I am writing regarding project **SSD-3846-Mod-1 – West Culburra**. I've raised the below concerns throughout the various stages of the proposed development (refer attached), however have seen minimal amendment to address the shortcomings of the proposed design. Subsequent to my previous submissions the following concerns are raised in relation to the proposed water quality treatment.

West Culburra Residential Subdivision, NSW (EPBC 2023/09524) – Notice for Public Information

WEST CULBURRA RESIDENTIAL DEVELOPMENT EPBC ACT REFERRAL – SUPPORTING DOCUMENTATION (EPBC 2023/09524)

Objection to West Culburra Mixed Use Subdivision – SSD-3846

Figure 3 Figure Showing Comparison of Flood Mapping as Provided on Shoalhaven City Council Website and the Figure Provided Within Allan Price and Scarratts Flood Impact Assessment Report.

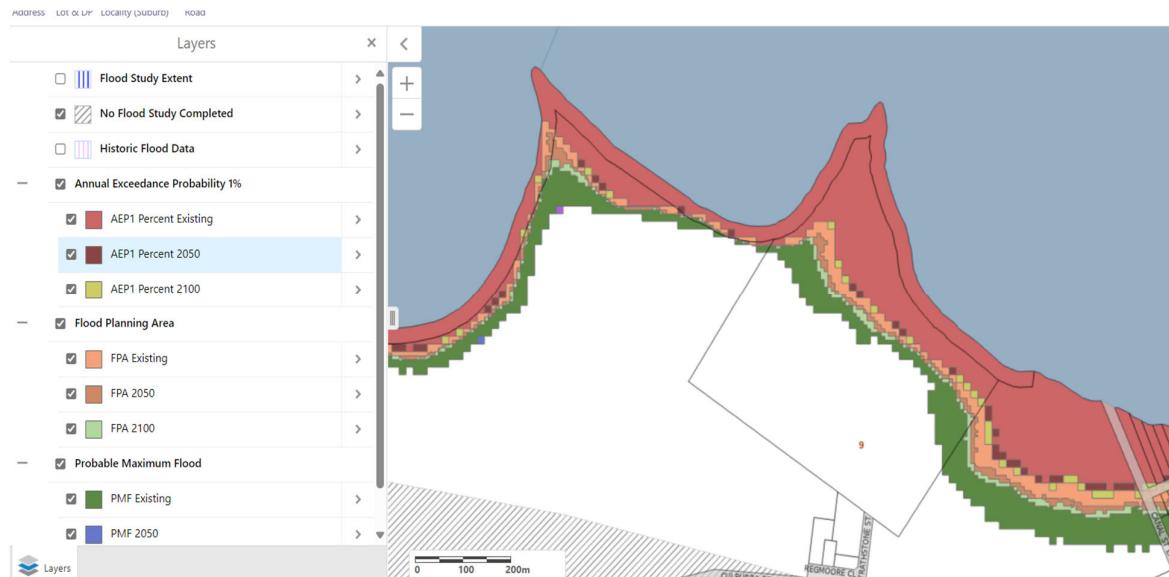
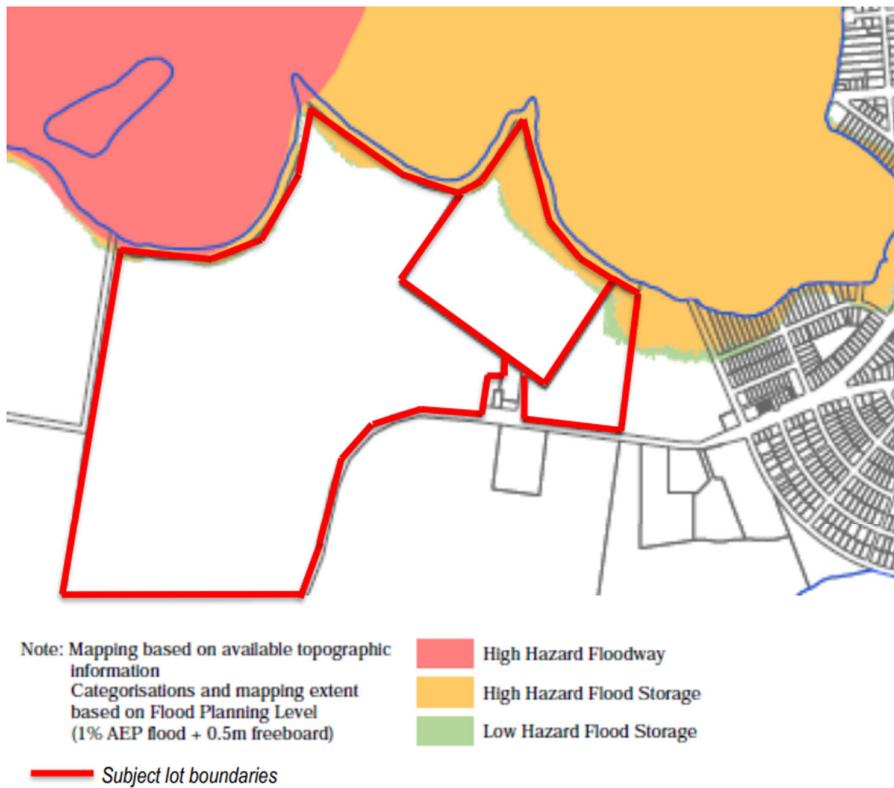
- The report provides a figure of the flood hazard mapping however contains no reference to the flood planning maps provided on Shoalhaven City Council's Interactive Mapping website to be used for development. This results in the impact assessment underestimating the extent of flooding at the subject site (Figure 3). The areas identified as flood prone on the mapping are within the location of the proposed water quality detention ponds which if inundated will result in water quality issues to the adjacent waterways.

Figure 4 Lower Shoalhaven River CMP (Rheilm, 2024) Figure Showing Coastal Wetland, Coastal Wetland Proximity Area and Areas of Environment Value which will be Directly Impacted by the Proposed Development.

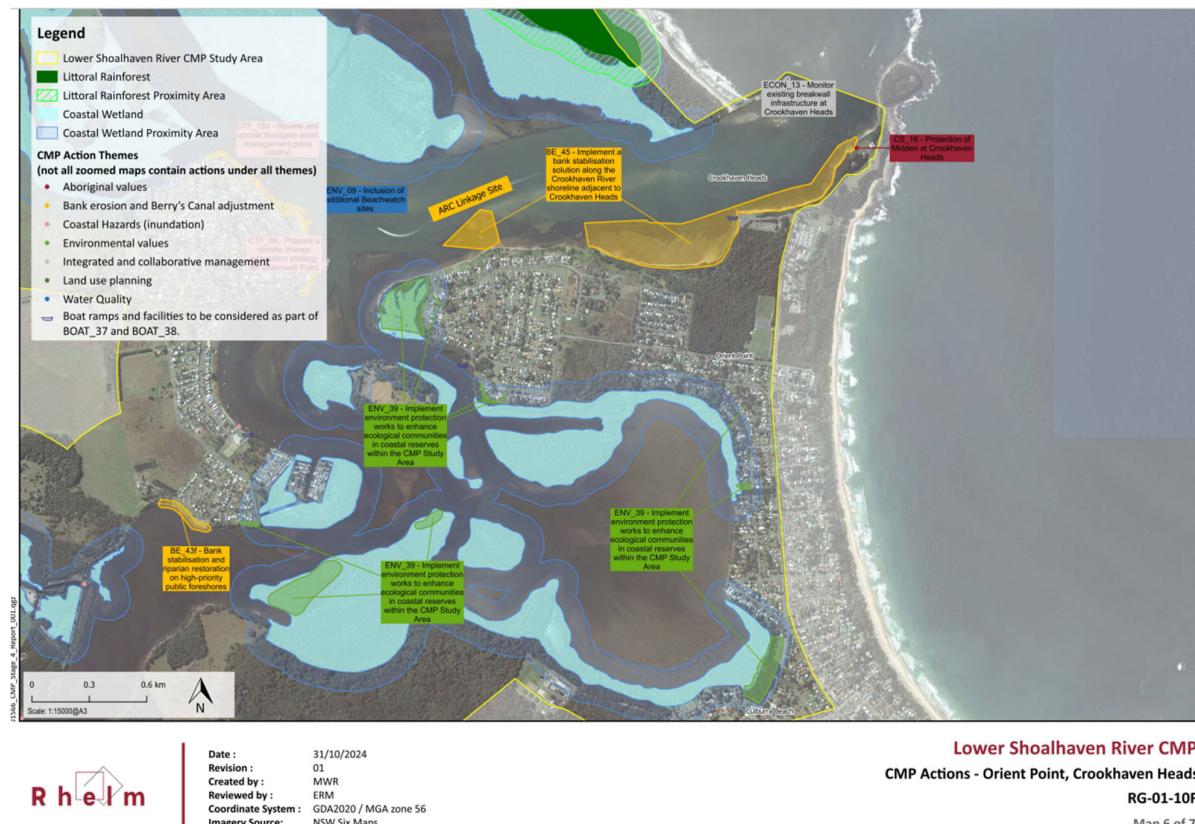
- The Flood Impact Assessment report provides no analysis on the potential impacts of tidal inundation nor climate change affects which will exacerbate the present-day scenario. The implications of this omission will be the need for Council to invest in future methods of asset protection to alleviate the impacts of flooding and tidal inundation.
- The most recent Lower Shoalhaven River CMP (Rhelm, 2024) depicts *Coastal Wetland Proximity Area* and areas identified as containing environmental values (Figure 4) which are going to be directly impacted by the proposed development.

Figure 2 Estuarine Macrophytes Adjacent to Proposed Development Site

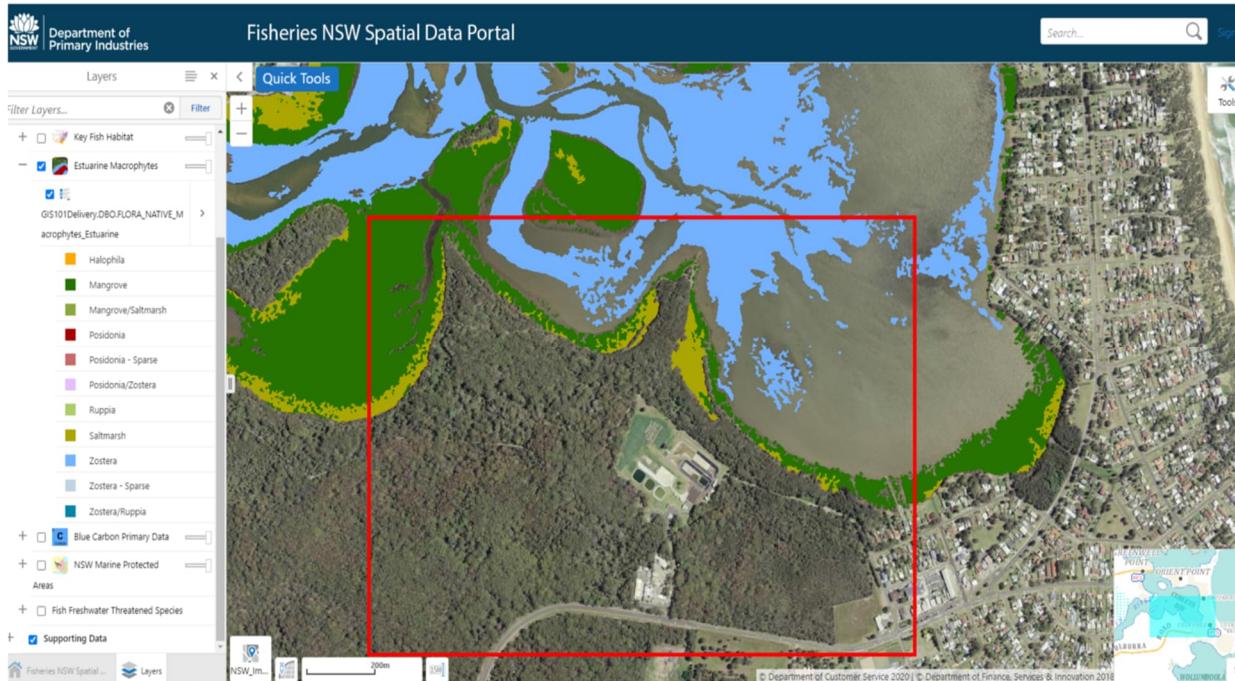
This section of the report contains no information regarding the NSW DPI mapping that indicates significant extent of Estuarine Macrophytes adjacent to the project site including Mangroves, Saltmarsh and *Zostera* as shown in Figure 2.

Figure 3 Biodiversity Value Area at Project Area

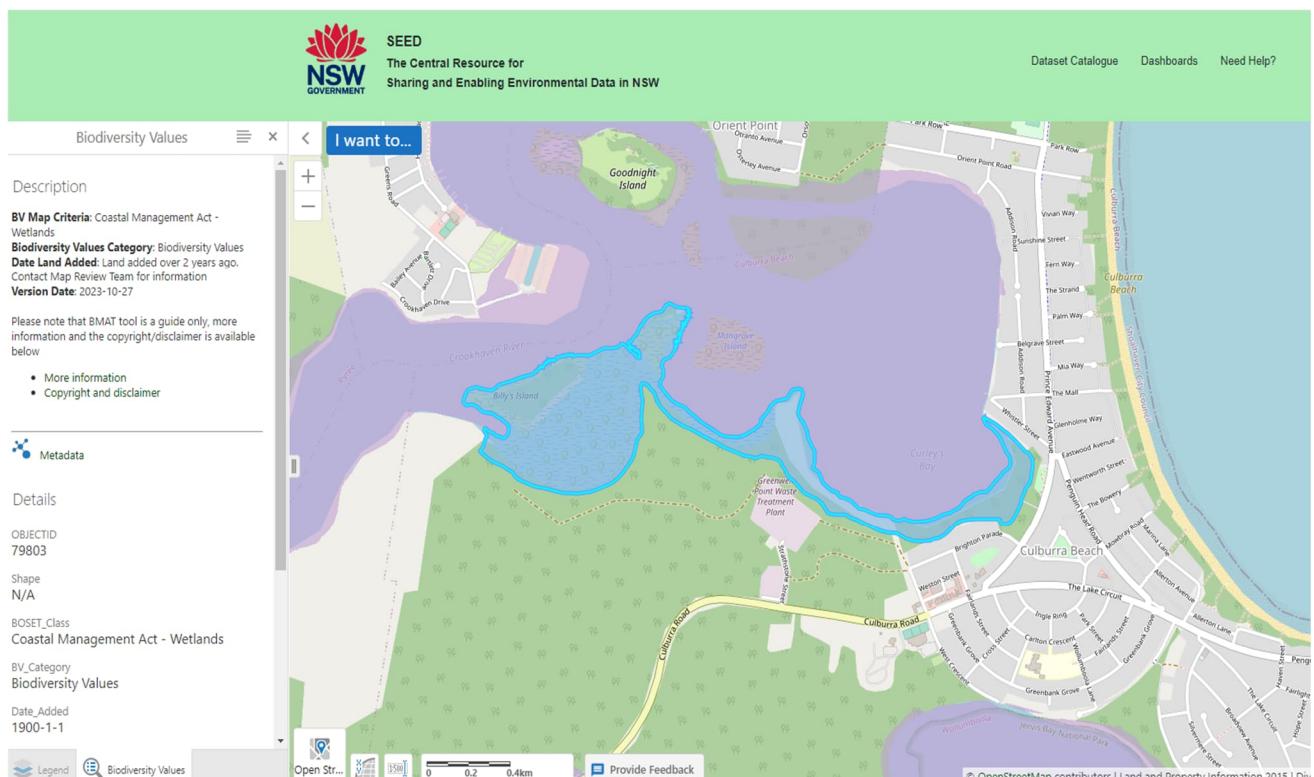
This section of the report makes no mention of the Biodiversity Value Area (Figure 3, Coastal Management Act, Wetlands) adjacent to the proposed Project Area. This would be classified as an outstanding natural feature.

Figure 4 Flood Mapping of Project Area and Inundation of Proposed Water Treatment Pond

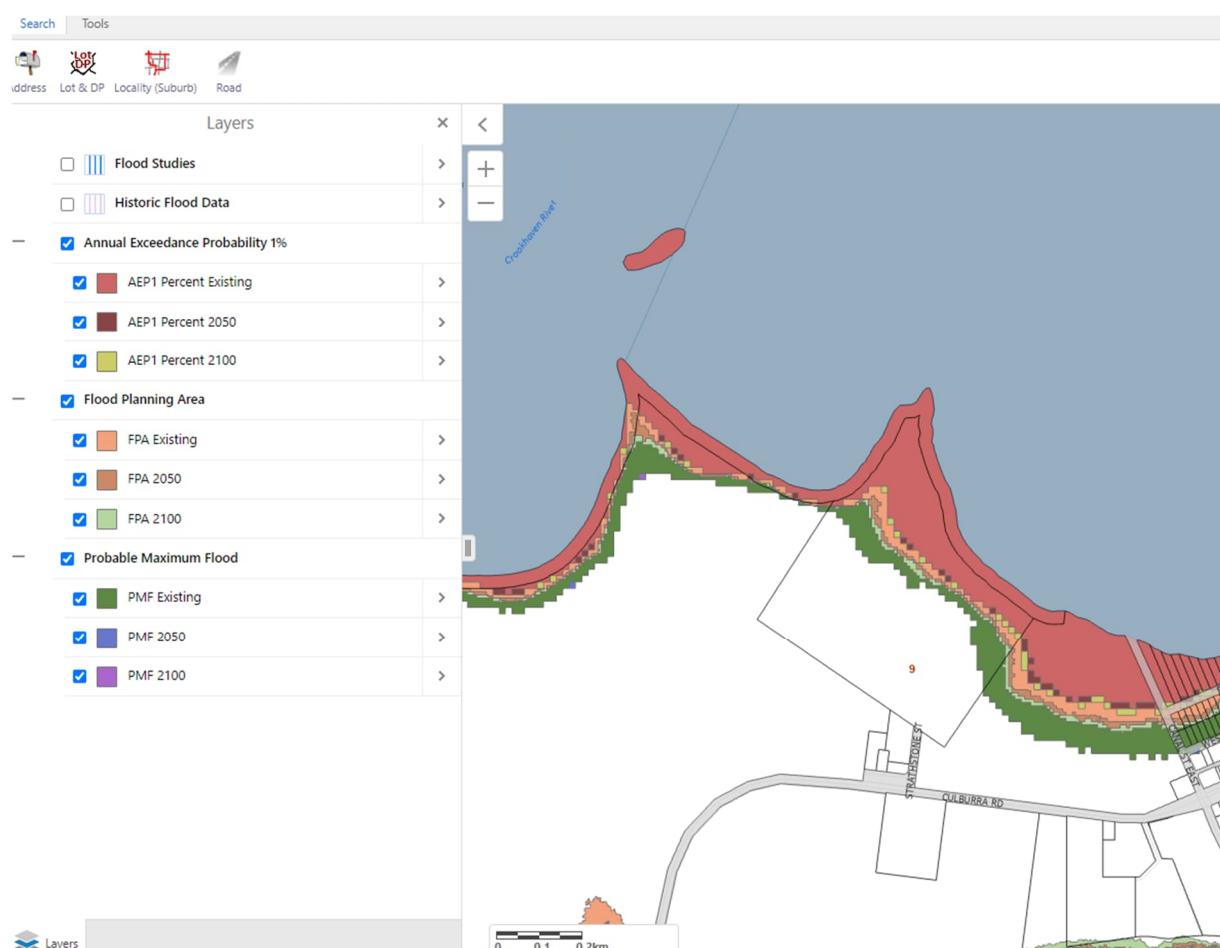
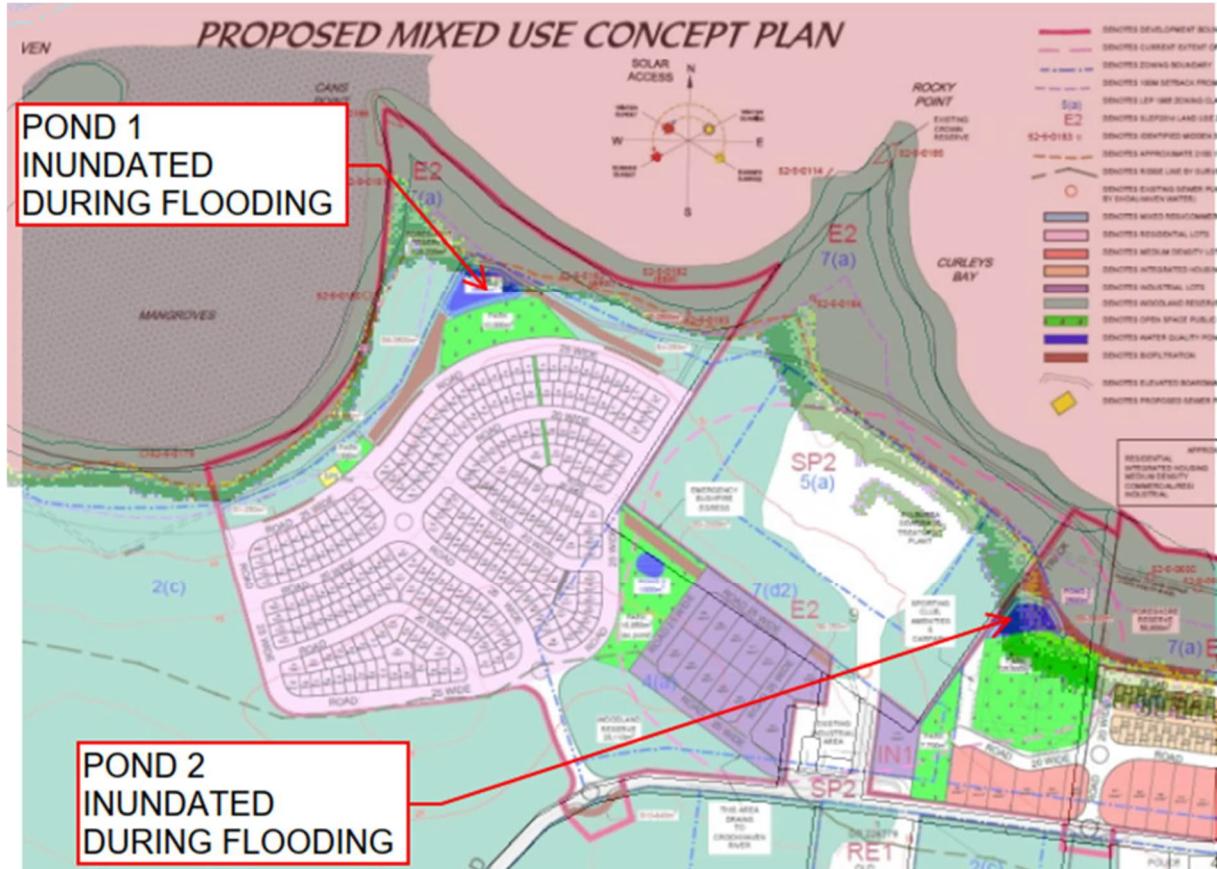
This section of the report makes no mention of the potential flooding of the Project Area. Figure 4 shows the latest flood mapping from Shoalhaven City Council and then the flood mapping superimposed onto the proposed development. The existing Probable Maximum Flood (PMF) level would directly impact the foreshore area of the Project Area. The proposed water treatment ponds (designed to collect and treat runoff to ensure it does not enter or pollute waterway) would be inundated during a flood event with subsequent pollution impact on the surrounding environment and Threatened Ecological Communities, this would have a permanent impact on protected matters.

Whilst the stormwater scheme (not referenced) will have no direct piped drainage to Curleys Bay there will be treated water released to the buffer zone, which will impact riparian communities including saltmarsh, mangroves, mudflats and seagrass. The report does not mention this nor the impact which would be ongoing.

Figure 1 Shoalhaven Flood Mapping Superimposed onto the Development Showing Areas of Inundation

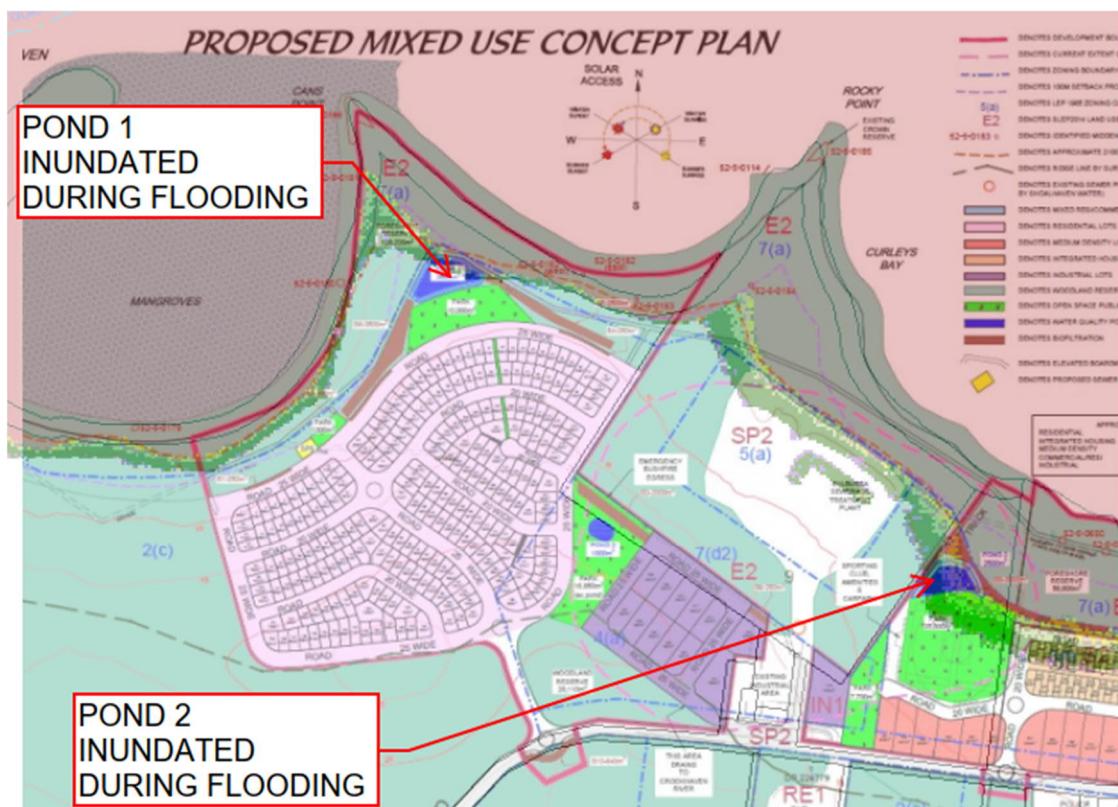
Further, the existing flood maps of the Shoalhaven (Figure 1) have been superimposed onto the proposed development and indicate that two out of three of the nominated sediment ponds are going to be inundated during a flood event. The function of the ponds is to store and treat runoff to ensure it does not enter or pollute the waterways. This function will not be achieved if the ponds are inundated during flooding. This will only get worse with increase in sea level rise and rainfall due to climate change. The obvious issues associated with the nominated locations of the ponds is concerning and highlights the inadequate assessment that has been undertaken in relation to the water quality implications resulting from the development.
